WPR23LA004

Group Chair's Factual Report - Attachment 1

Bell Alert Service Bulletin No. 206-20-139

SUBJECT: SEGMENTED TAIL ROTOR DRIVESHAFTS 206-040-330-003/-101, 206-040-931-009/-011/-101/-103, 206-040-365-101/-105/-121/-123 WITH BONDED ADAPTERS, PROOF LOAD TEST OF.

Figure 1 – Bonded Shaft Tool (206-244-001-101)

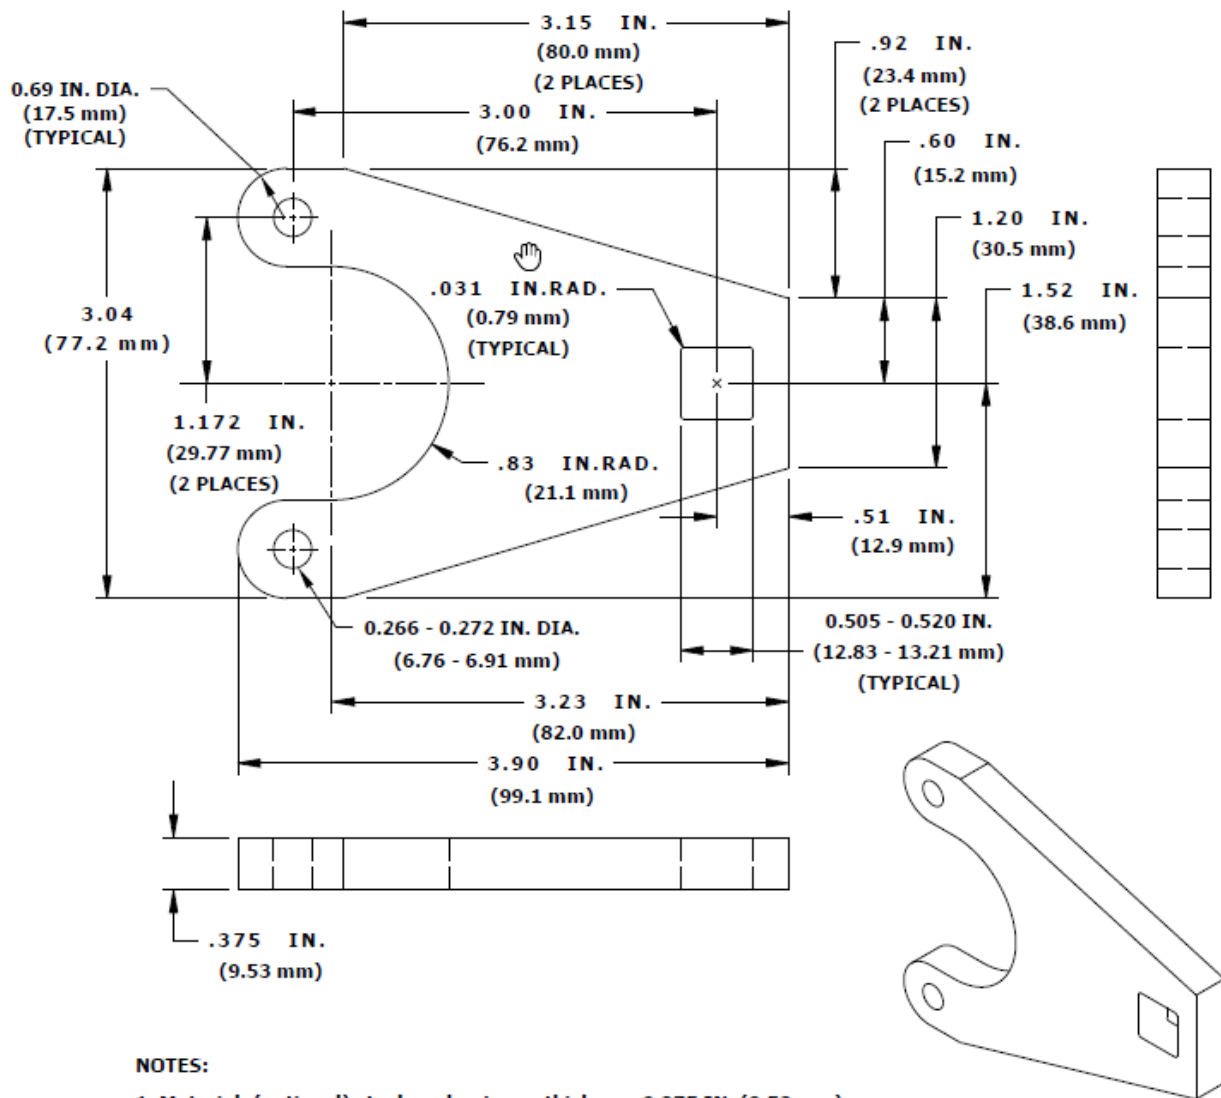
Revision A allows failed bonded tail rotor driveshafts to be replaced with serviceable bonded driveshafts that meet the intent of this bulletin and makes corrections to some of the metric dimensions in Figure 1 of this bulletin. It is also being used to inform owners and operators that some helicopters outside of the **HELICOPTERS AFFECTED** serial number range may have been modified with segmented bonded shafts through local aviation authority approvals; in this case, the bulletin shall be carried out on those helicopters as well.

The bonded shaft tool part number 206-244-001-101 (QTY 2 required) can be procured through your Bell Supply Center or locally manufactured using the information provided on Figure 1.

If the forward short shaft is removed, install the (206-040-328) sliding adapter and work aid (Bonded Shaft Tool 206-244-001-101) on the forward splines of the oil cooler fan shaft. The bonded shaft tool 206-244-001-101 can be locally manufactured using the information in Figure 1 or can be purchased from a Bell Supply Center.
